### APPLICATION FOR A CERTIFICATE OF APPROPRIATENESS – STAFF REPORT

027-18-CA 514 COLE STREET

<u>Nature of Project</u>: Construct detached garage; plant evergreen foundation screening Staff Notes:

SECTION A-B

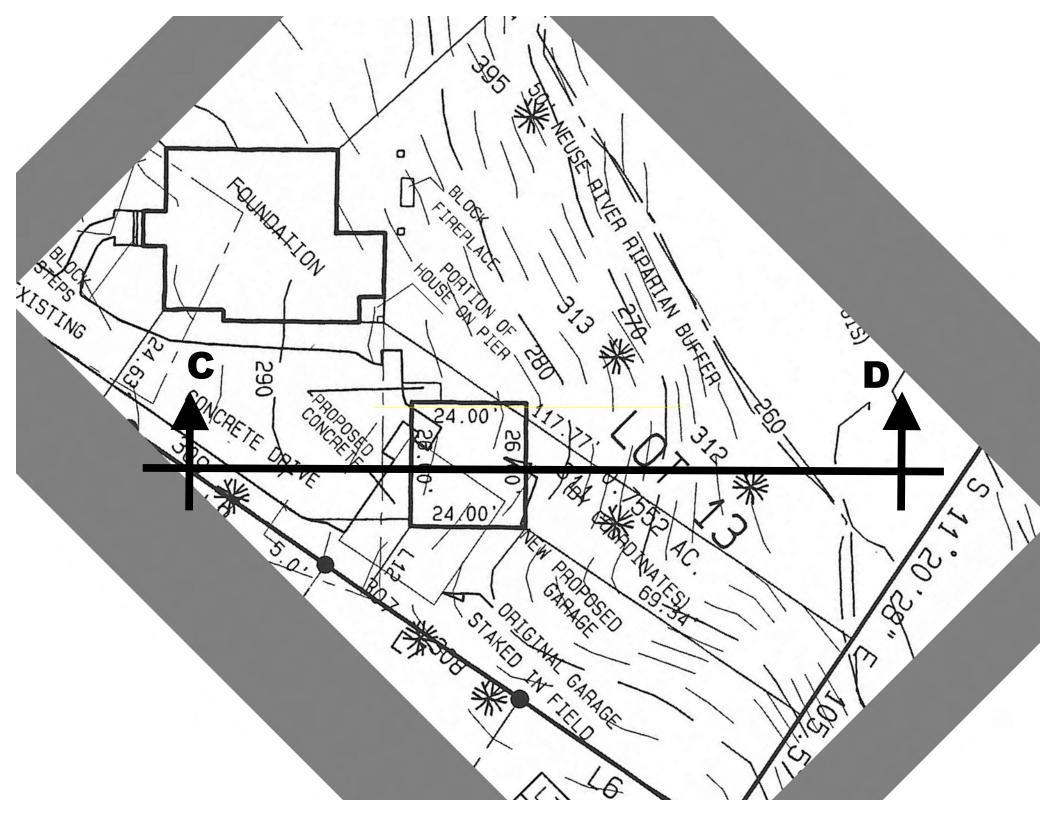
- 7\* The application includes a section cut perpendicular to the street (A-B) that illustrates the relationship of the proposed garage to the grade at Cole Street. That drawing shows the

- floor of the garage as being roughly 12 feet lower than Cole Street. Based on this, the ridge of the garage is effectively 9'9" above Cole Street.
- 8\* The application includes a section cut perpendicular to the garage (C-D) that illustrates the grade of the lot in relationship to of the proposed garage. That drawing shows that from the floor of the garage, the lot drops roughly 70 feet to the creek at Wade Avenue.
